**Request for review - Transalloys Manganese Alloy Smelter Energy Efficiency Project
(UNFCCC ID 1027)**

EcoSecurities, on behalf of project participants to the above project (EcoSecurities Group Plc and Highveld Steel and Vanadium Corporation), would like to provide the following response to the comments raised by the three requests for review dated 13 June 2007.

Figure 7b: Sensitivity analysis – Summary of results (copied from updated PDD page 18)

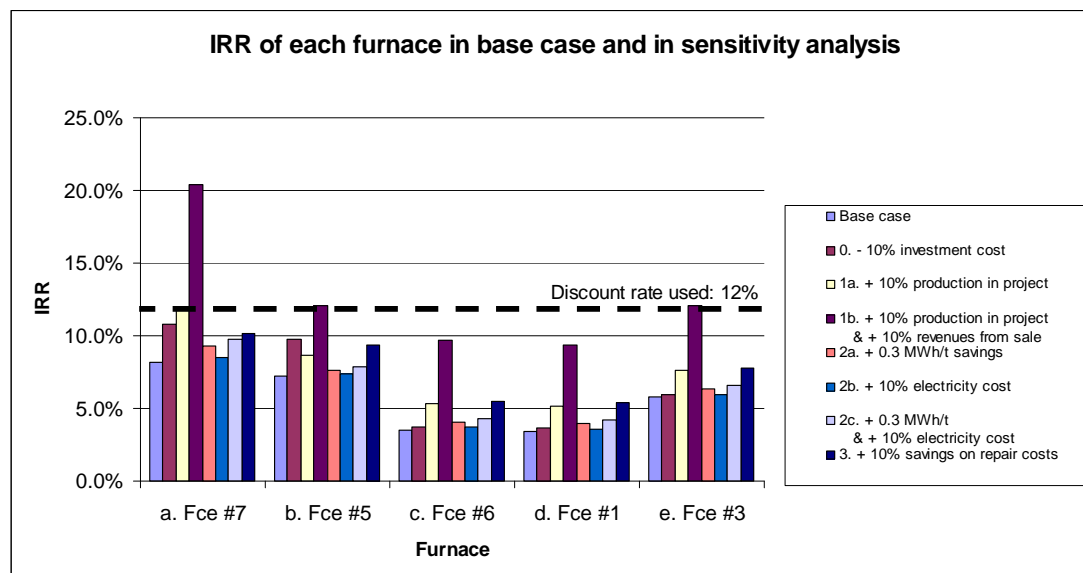
“A clear investment and sensitivity analysis for all 5 furnaces explicitly following step 4 of AM0038 has not been conducted to demonstrate that the project activity without the CDM is economically less attractive than the most plausible baseline scenario.”

A sensitivity analysis has now been performed, and the results are summarised in the graph given below in Figure 7b (see Table 7b of the updated PDD for the actual figures). It shows that the NPV remains negative (i.e. IRR below the discount rate 12%) in all sensitivity cases, except when we combine favourable sensitivity scenarios, such as +10% production in project and +10% revenues from sales. However, such scenarios are unrealistic to achieve consistently and, maybe more importantly, very uncertain. For example, revenues from sales have increased since the retrofit (because of higher metal prices) but, more crucially, the retrofit of furnaces has resulted in a net decrease in production. This means the project has resulted in significant losses compared to the baseline scenario (see Table a. at the end of this document).

- However, the sensitivity analysis above shows that, even with a combination of favourable scenarios, the NPV of the project activity remains relatively low and, perhaps more importantly, highly uncertain – due to the variation of both internal parameters (saving rates, production rate, etc) and external parameters (exchange rate, selling price).
